SERVICE BULLETIN

_{N°} 139-734

DATE: April 13, 2023

ATA 25 - LIFE RAFT INFLATION SYSTEM REPLACEMENT

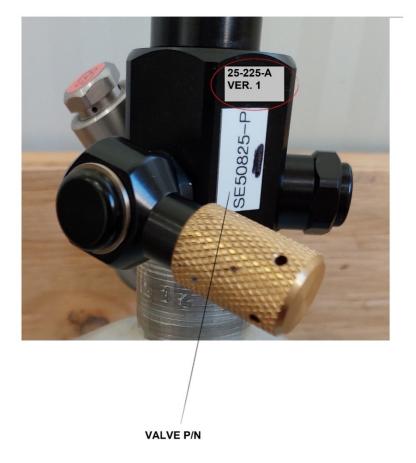
- the Aero Sekur Service Bulletin SB-139-25-005 or Survitec Service Bulletin SB 25-225-A is already marked on the Collective Emergency Life Raft Log Card and on the relative label, where the affected Inflation System is fitted (ref. to Figure 3);
- the Survitec Service Bulletin SB 25-225-A is already marked on the affected Inflation System (ref. to Figure 3).

ASB 25-225-A VERI APPLIED
